SCHWEIZER SERVICE LETTER

SUBJECT: STRUCTURAL ENHANCEMENT OF TAIL ROTOR PEDAL MOUNT

MODELS AFFECTED: All 269D Model Helicopters.

**TOP PEDAL SUPPORT
ATTACHMENT BOLT HOLE**

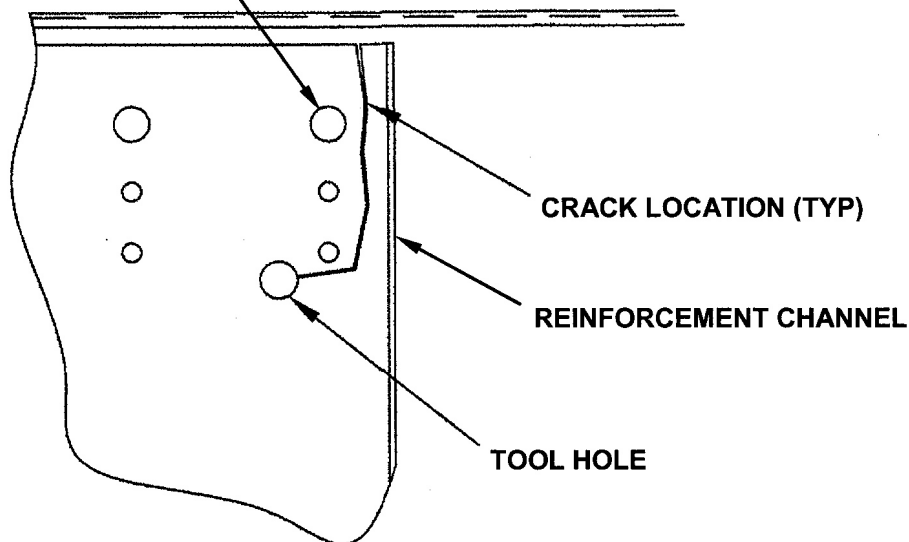
Service Bulletin DB-022 was issued requiring inspection of the tail rotor pedal attachment structure and installation of the SA-269DK-40 reinforcement kit. Additional cracks have been reported in some aircraft on the left side of the helicopter. The cracks are located near the flange radius of the reinforcement channels of the pedal support structure. The cracks start at the top right side and propagate down along the edge of the top nut plate to an empty tool hole (see figure below). During the 100 hour inspection of the pedal support structure, if these cracks are noted, they can be repaired by installing an SA-269DK-44 Repair Kit. Due to the amount of floor structure that must be removed to gain access to the damaged areas, it is recommended that the SA-269DK-44 kit be installed at the same time the SA-269DK-40 kit is installed.
